2 Responses to Comments

This chapter contains comments received during the public review period for the Kings Beach State Recreation Area Preliminary General Plan Revision and Draft EIR/Kings Beach Pier Rebuild Project Draft EIR/EIS (Draft EIR/EIS), which concluded on June 29, 2018. Comments include comment letters, reproduced in their entirety, and summary notes of comments received during the public hearings before the TRPA Advisory Planning Commission (APC) on June 13, 2018 and before the TRPA Governing Board on June 27, 2018. In conformance with Section 15088(a) of the State CEQA Guidelines, written responses were prepared addressing comments on environmental issues received from reviewers of the Draft EIR/EIS.

2.1 List of Commenters on the Draft GP EIR/ Pier Draft EIR/EIS

Kings Beach State Recreation Area General Plan

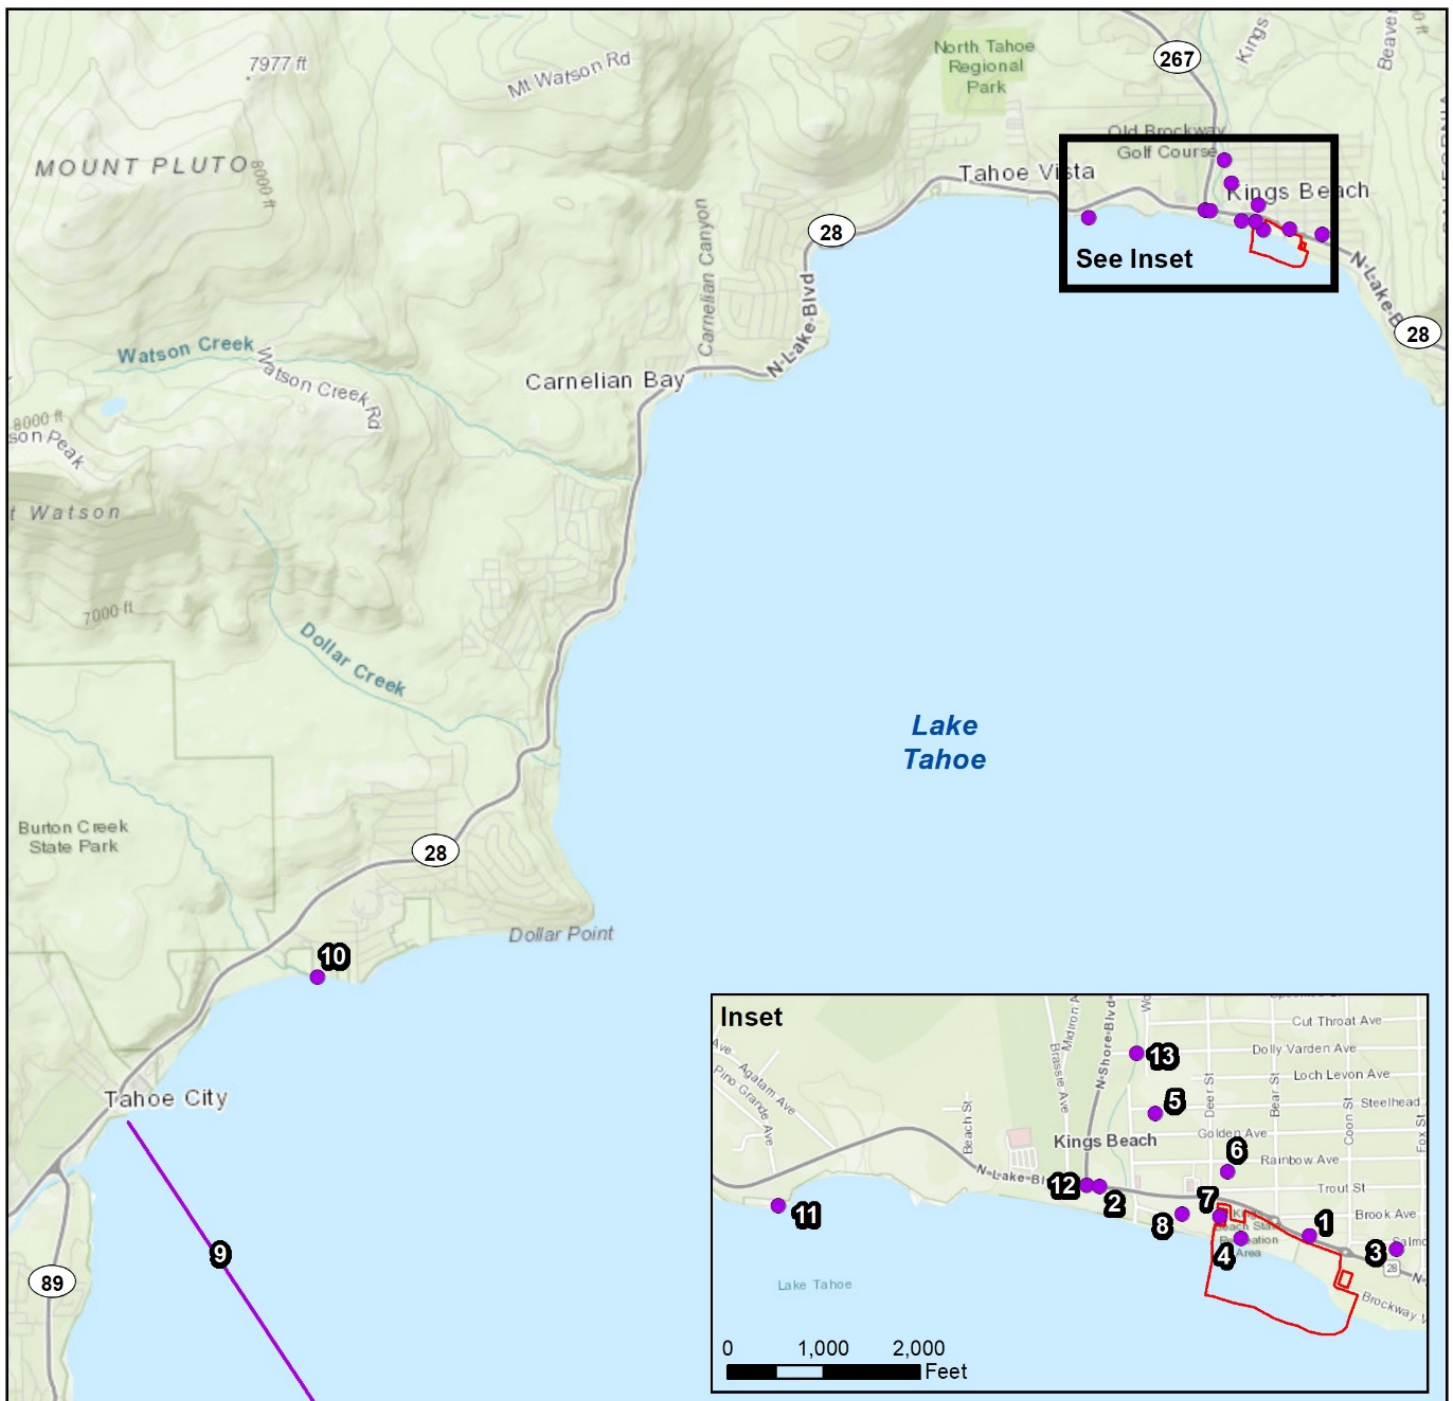
- 2-4 The comment requests that the Lakeside Redevelopment project at 8200 North Lake Boulevard and the Kings Beach Center project located at 8675 North Lake Boulevard be included in the cumulative impacts project list in Table 5.1-4 of the Draft EIR/EIS. The Kings Beach Center project is included in Table 5.1-4 as the Kings Beach Center Design Concept. It is assumed that the proposed Kings Beach Center project would be consistent with the land uses and maximum development potential considered as part of

In response to this comment, portions of Table 5.1-4 beginning on 5-32 and Exhibit 5.1-15 on page 5-36 of the Draft EIR/EIS are revised as follows:

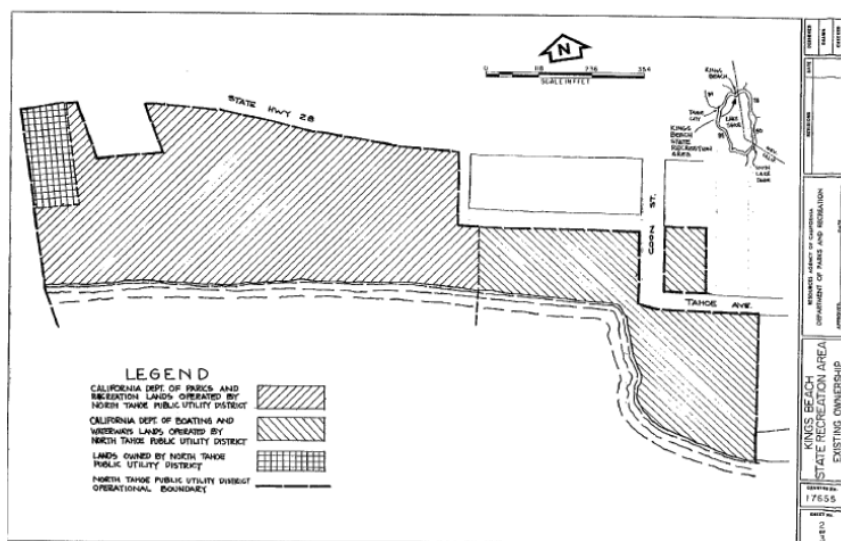
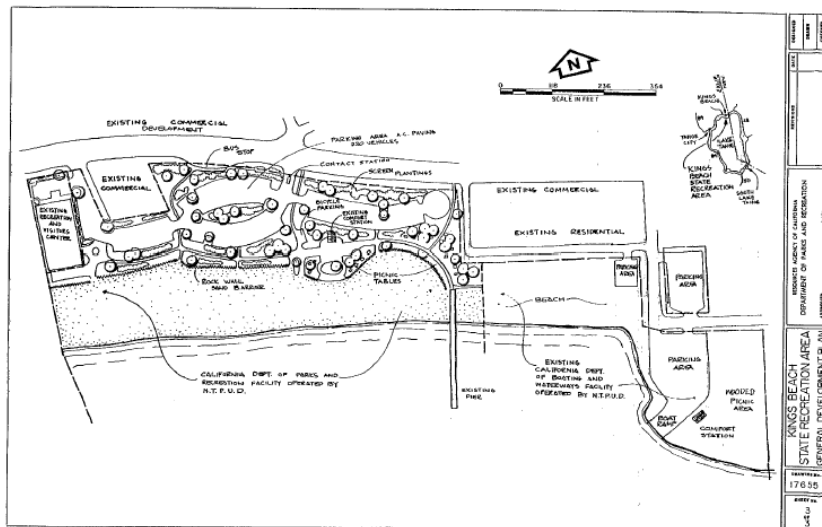
7). The environmental documentation must include the three maps below and must be updated to reflect what is on the ground today as well as what is being proposed as part of this project

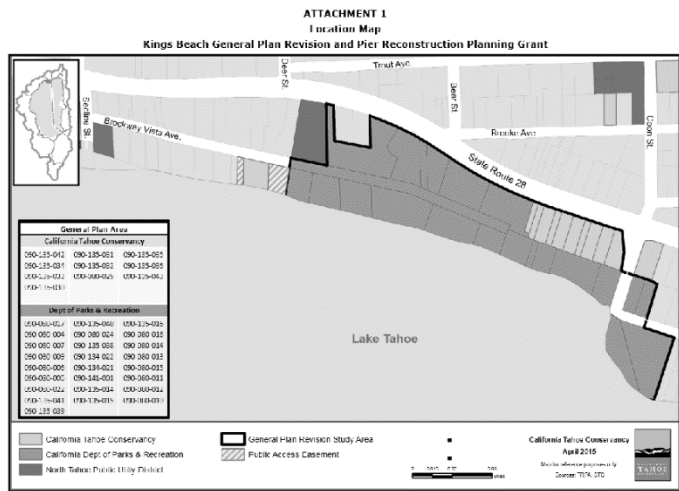
From NOP: The proposed project is a General Plan revision for KBSRA and the Conservancy plaza parcel by DPR and approval for reconstruction of the Kings Beach Pier that complies with all applicable TRPA and state laws, planning guidelines, policies, and regulations. The existing General Plan was approved in 1980 and only addresses 6.82 acres of the park/beach lands. At the time, the plaza area was occupied by dilapidated commercial buildings and the boat ramp/parking was owned and operated by the California Department of Boating and Waterways (DBW; now the Division of Boating and Waterways, a branch of DPR). The boat ramp and associated parking will be added to the KBSRA with the General Plan revision. The plaza will also be covered by the General Plan. A General Plan revision is necessary to incorporate the additional areas formerly owned by DBW and those areas within the KBSRA General Plan planning boundary owned by the Conservancy. The revised General Plan will also provide a long-term and comprehensive framework for the management of the 13.91 acres that it covers.

13). What does the 13.91 acres encompass and are proposed changes going to be addressed as part of this Project? And how does the KB Charette Vision align with the alternatives?

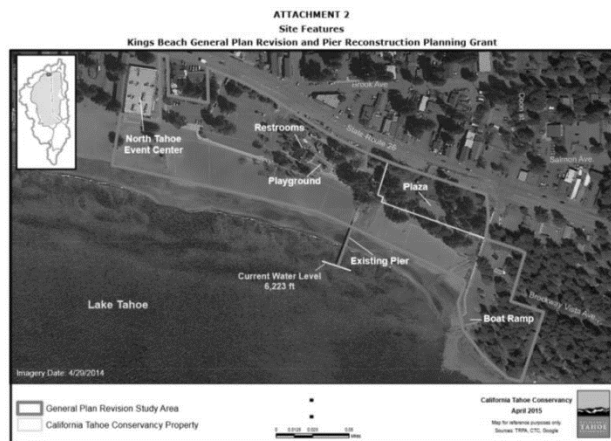
15). The environmental documentation must include maps showing APN designations and ownership so the public better understands which agencies own the parcels affected.
